UNITED STATES PATENT AND TRADEMARK OFFICE

APPLICATION NO.	FILING DATE	FIRST NAMED INVENTOR	ATTORNEY DOCKET NO.	CONFIRMATION NO.
09/851,576	05/10/2001	Yao-Ching Su	ADTP0033USA	3197

Office Action Summary

DETAILED ACTION

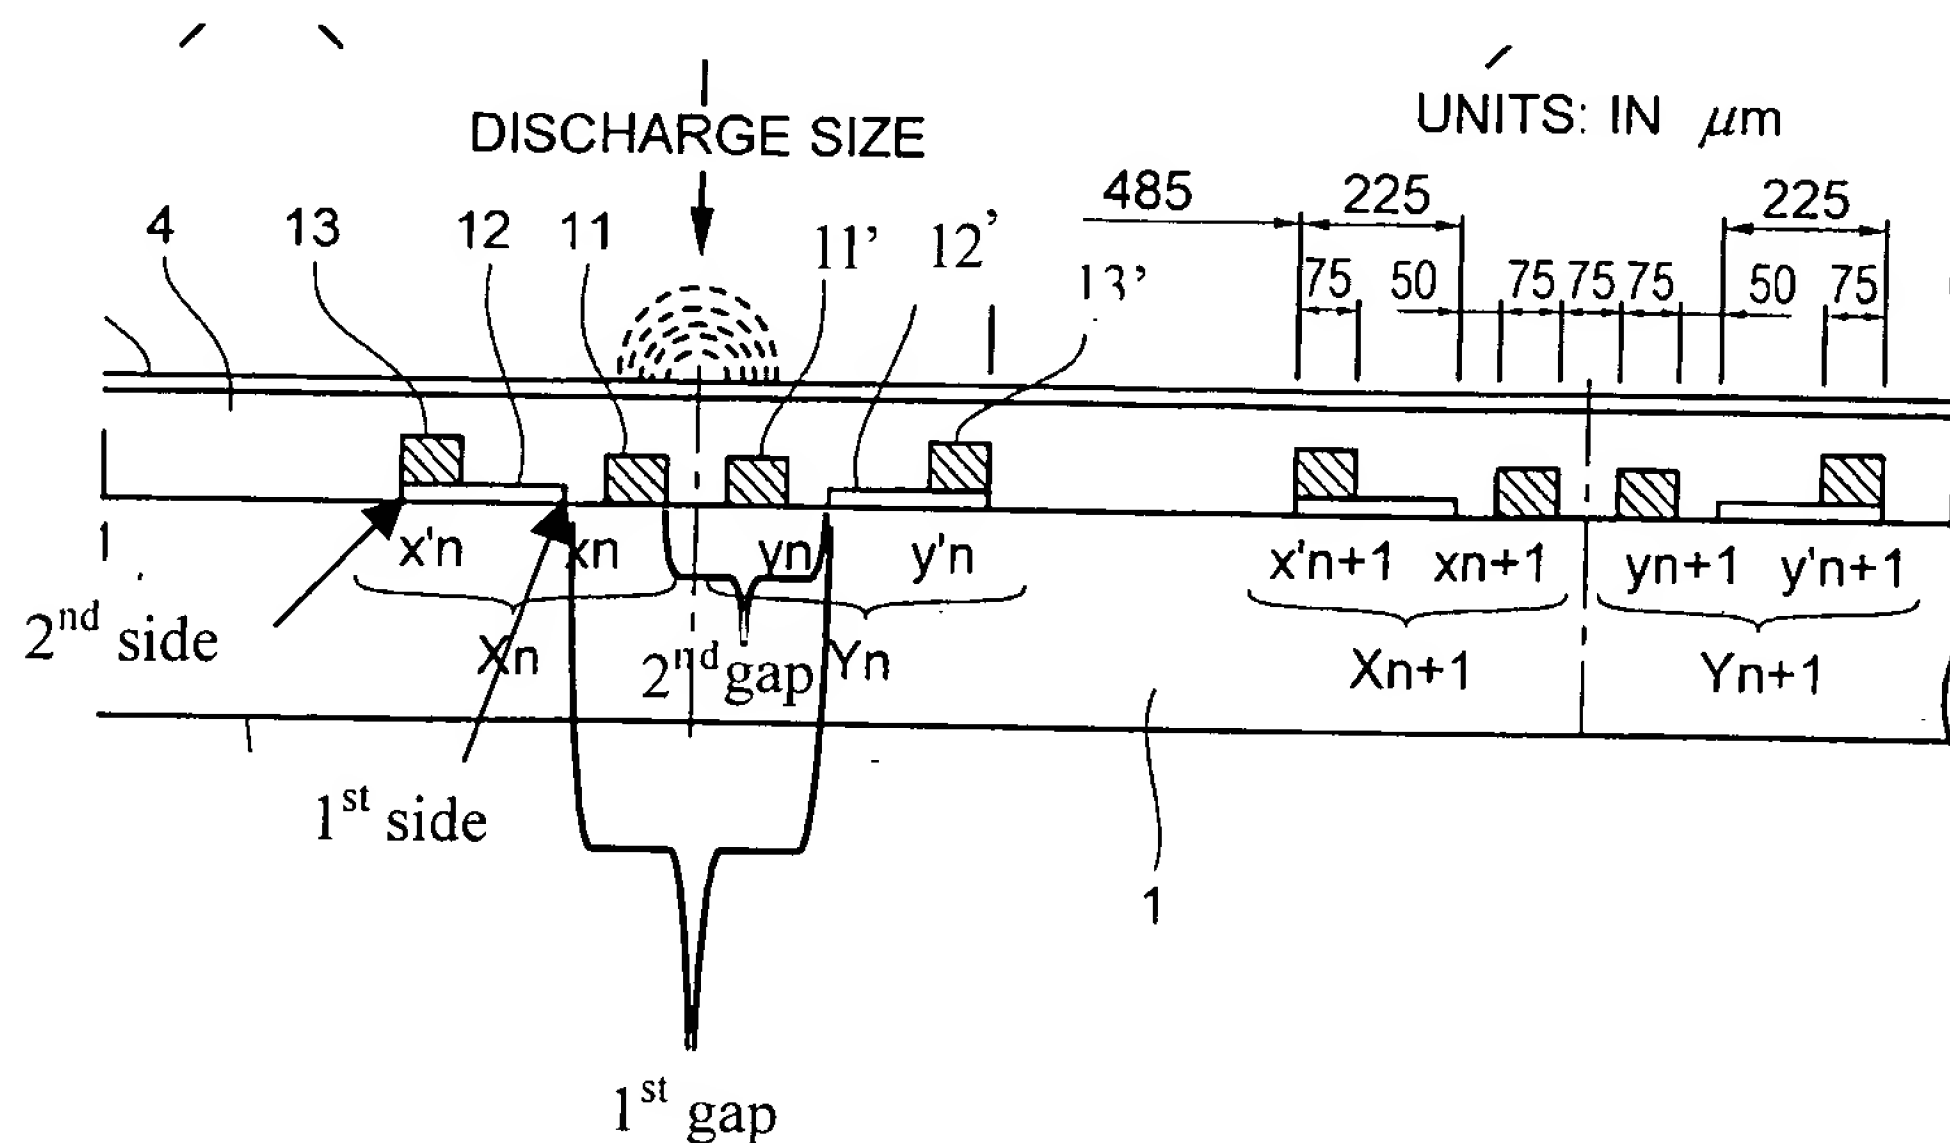
4. Claims 1, 9-12, 14-18, and 21 are rejected under 35 U.S.C. 102(b) as being anticipated by Nagano (USPN 6,031,329).
5. In regards to claims 1 and 9, the Examiner refers to reference numerals of Nagano's figure 1 as shown below. Nagano discloses in figure 1, an electrode structure of a plasma display panel with a first sustaining electrode (12) and a second sustaining electrode (12') set on the surface of the front substrate (1), and a first gap (shown below) existing between the first and second sustaining electrodes; a first auxiliary electrode (Xn) electrically connected to the first sustaining electrode, the first auxiliary electrode comprising a first part (11) and a second part

(13) adjacent to the first part, the first part formed in the first gap and the second part located above the first sustaining electrode; wherein a second gap (shown below) existing between the first part of the first auxiliary electrode and the second sustaining electrode, and the width of the second gap is smaller than the width of the first gap.

6. The Examiner notes that the discharge gap of Nagano exists between the two discharge electrodes, X_n and Y_n . Because the second auxiliary electrode (11') is electrically connected to the second sustaining electrode (12'), an electrical discharge will occur in the second gap.
7. In regards to claim 10, Nagano discloses all of the recited limitations of claim 9 (above).
8. Nagano further discloses that the first sustaining electrode comprises a first side approaching to the second sustaining electrode and a second side not contiguous to the end of the second sustaining electrode (12'), the first auxiliary electrode (X_n) comprises a first part (11) and

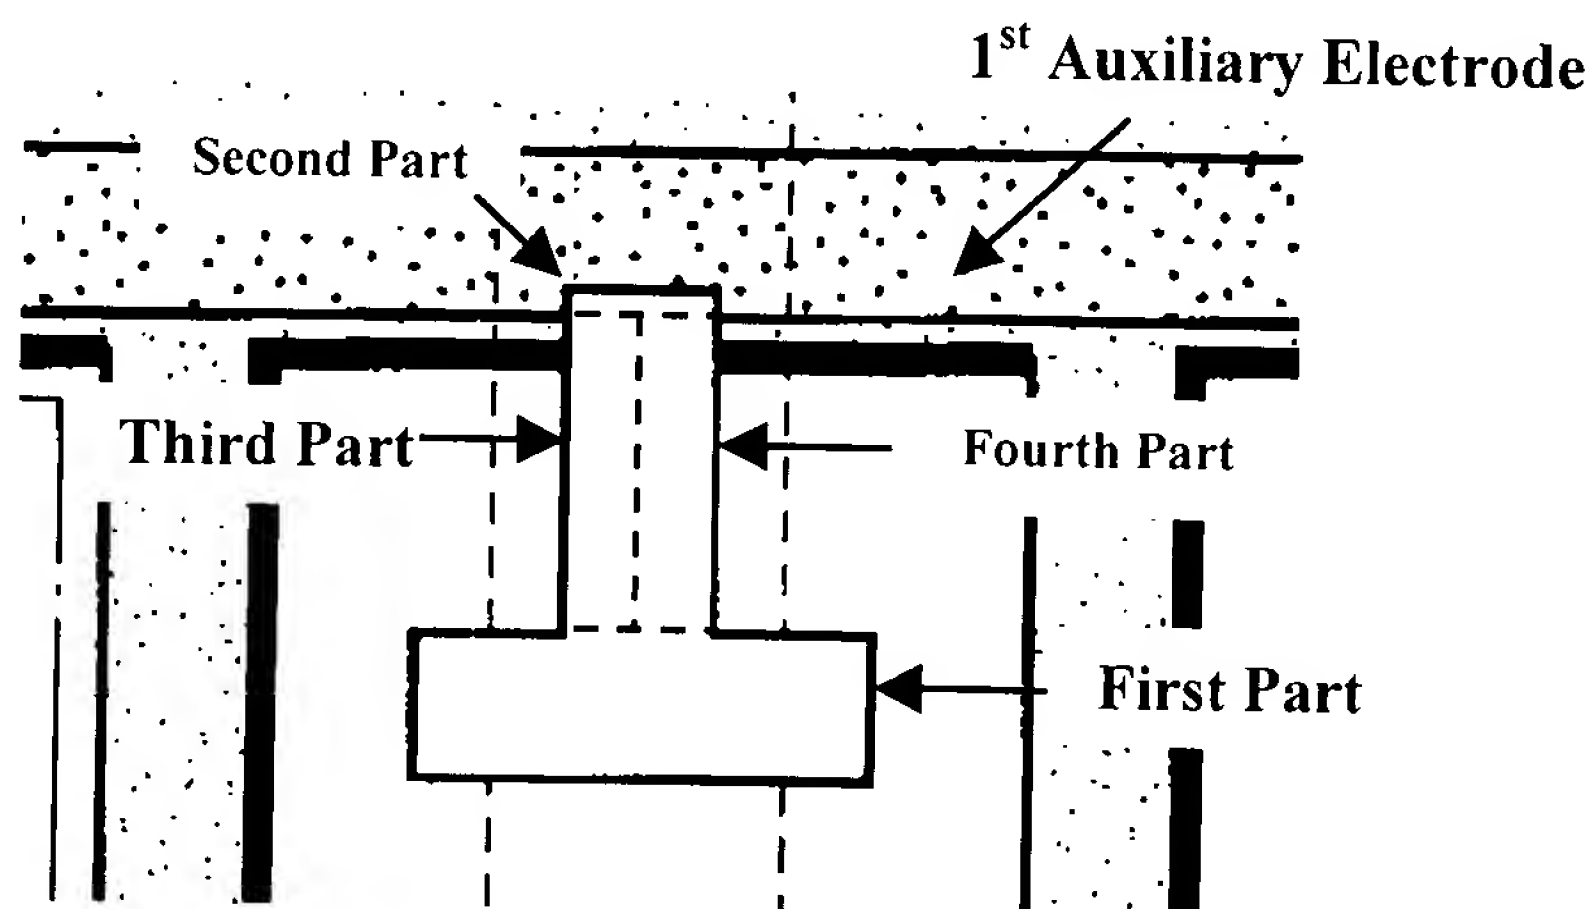
21. Claims 2-8 and 13 are rejected under 35 U.S.C. 103(a) as being unpatentable over Nagano (USPN 6,031,329) in view of Koshio et al. (USPN 6,465,956; "Koshio").

22. In regard to claims 2-4, Nagano discloses all of the recited limitations of claim 1 (above).

23. Nagano is silent to the first auxiliary electrode further comprising a third part.

24. However, Koshio teaches in figure 1 that the first auxiliary electrode further comprises a third part (shown below) which is located on the first sustaining electrode, and approaches the second side of the first sustaining electrode. Koshio further teaches in figure 1 that the third part of the first auxiliary electrode is on the surface of the front substrate, and this configuration improves the fineness for a picture being displayed on the panel (column 2, lines 32-33).

25. Therefore, it would have been obvious to one having ordinary skill in the art at the time the invention was made to construct the electrode structure of Nagano, including the third part on the first auxiliary electrode which approaches the second side of the first sustaining electrode, since Koshio teaches this configuration improves the fineness for a picture being displayed on the panel.
